# Work Order ID 99494

Item ID: D135-692-011 Accept **\*N900040100\*** Setup Start **\*NS1\***  
 Revision ID: Stop **\*NS2\***  
 Item Name: Bearpaw  
 Start Date: 4/10/2013 Start Qty: 4.00 **\*4\*** Cust Item ID:  
 Required Date: 4/26/2013 Req'd Qty: 4.00 **\*4\*** Customer:  
 Reference:

# DART SERVICE INSTRUCTION

TO AMEND INSTALLATION INSTRUCTIONS IIN-D135-692 REV. A AND  
INSTRUCTIONS FOR CONTINUED AIRWORTHINESS ICA-D135-692 REV. 0  
REF. FAA STC: SR01042SE

Figure 2 - Bearpaw Installation (IIN-D135-692)  
Figure 32-2: Bearpaw Installation (ICA-D135-692)

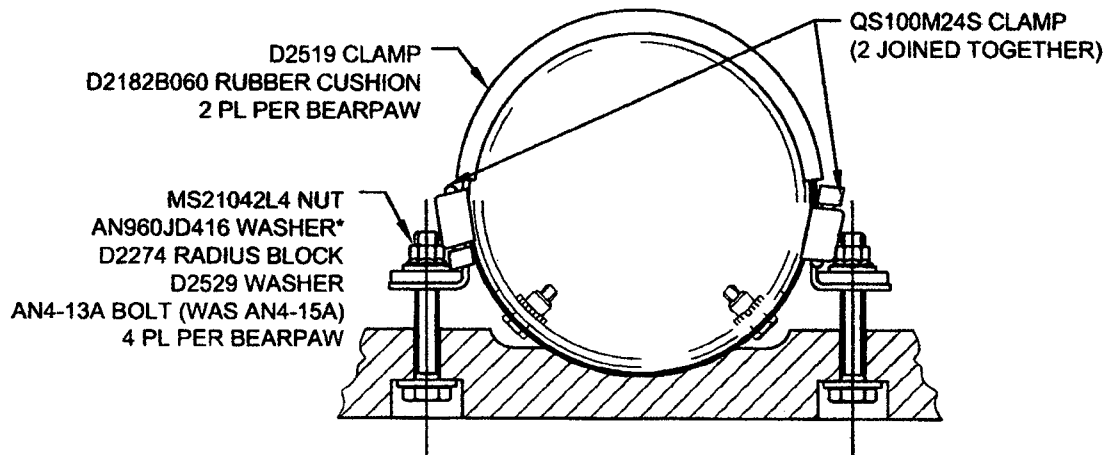
The purpose of this service instruction is to replace the AN4-15A Bolt with a shorter AN4-13A Bolt to facilitate installation.

Figure 2 of IIN-D135-692 and Figure 32-2 of ICA-D135-692 are amended as follows:

## IS:

8	AN4-13A	BOLT
---	---------	------

## WAS:

8	AN4-15A	BOLT
---	---------	------
